**From:** Gus Williams [gwilliams@ducks.org]  
**Sent:** Tuesday, July 05, 2016 11:54 AM  
**To:** Jeff Merrill  
**Cc:** Steve Liske  
**Subject:** RE: Jeff's and Curt's comments/questions - 90% designs

**From:** Jeff Merrill [mailto:Jeff.Merrill@oregonmetro.gov]  
**Sent:** Tuesday, July 05, 2016 10:50 AM  
**To:** Gus Williams  
**Cc:** Steve Liske  
**Subject:** Jeff's and Curt's comments/questions - 90% designs

PROJECT NO. US-OR-32-8	DATE 6/22/2016	DESIGNED BY GW
METRO: MULTNOMAH CHANNEL NORTH SITE		DRAWN BY CMC
WCS IMPROVEMENTS		SURVEYED BY
		CHECKED BY
		SHEET NO. 8 of 18

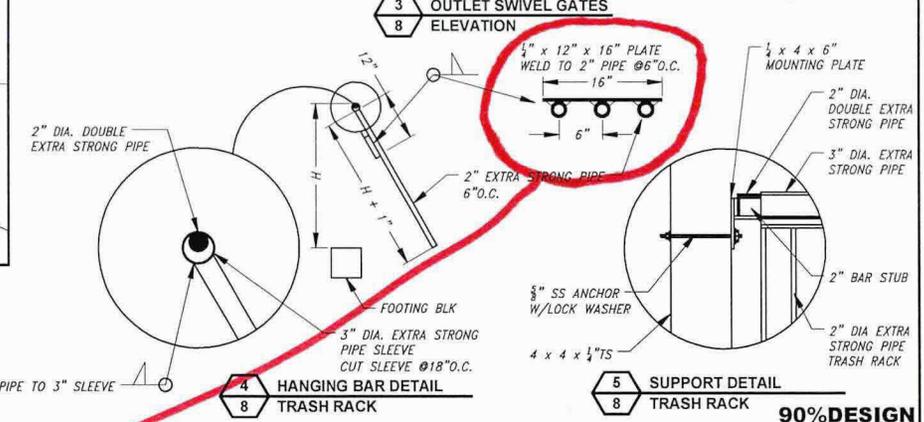
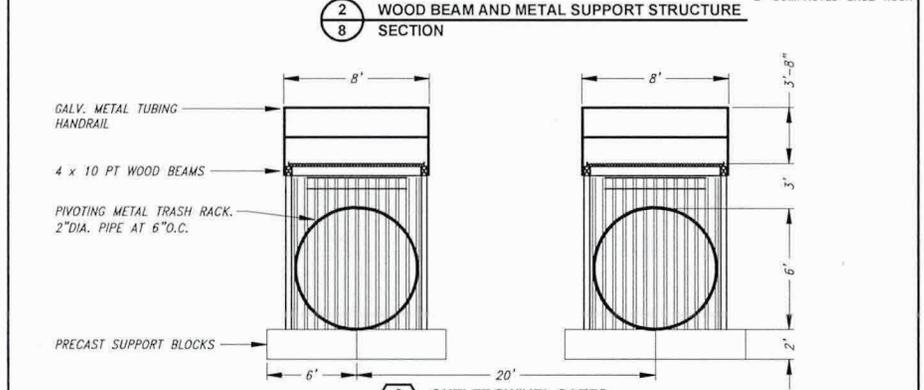
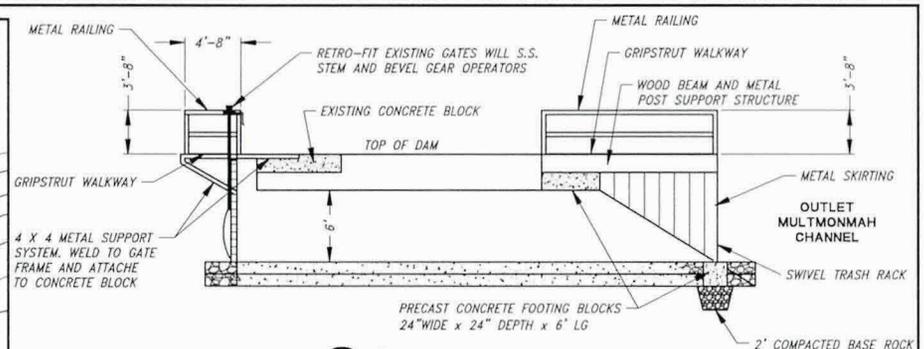
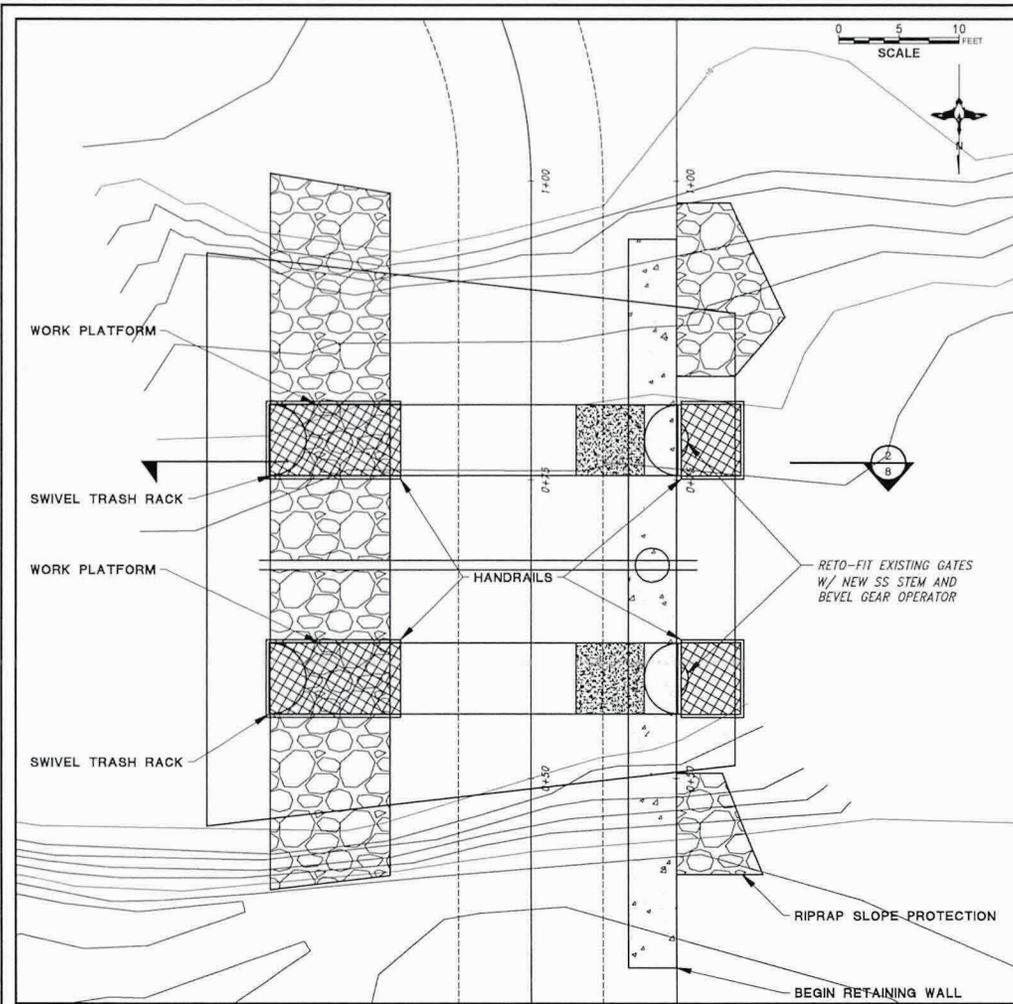
- Drawing 1 – 8: Stair access on both the headworks and the tailworks grating was mentioned in the Phase 2 scope of work. Is this shown on the design drawings? **There is no need for stairs at this location. The walkway will be at same elevation as the top of structure.**
- Drawing 4 – 8: Just want to confirm that this specifies a 6" gap between the bars of the trash rack (applies to Drawing 4-6 as well) for adequate fish passage. **There is a 4" clear gap between bars in this design. We can change if needed.**

- Drawing 3 – 8: Labeled ‘outlet swivel gates: elevation’ – see comment above for Drawing 3 – 6 on consistency/clarity. **Horizontal swivel trash rack is proper description**
- P. 11 of 16
  - Drawing 5 – 11: note says “Full set of aluminum stop logs. No(t) required for center bay”. Just wanted clarification on this...I think we’re only putting new stop logs in the fishway, so I assume this refers to the center bay of the fishway. If I’m correct I couldn’t remember why we didn’t need logs there. **Aluminum Stoplogs are for the fish ladder entrance only. The center bay does not use stoplogs. There is a vertical slot baffle used in this bay. No plan to replace. Should we make this out of Aluminum?**

CONFIRMING THAT THIS SPECS A 6" GAP BETW. THE BARS IN THIS TRASH RACK? IF SO - OK.
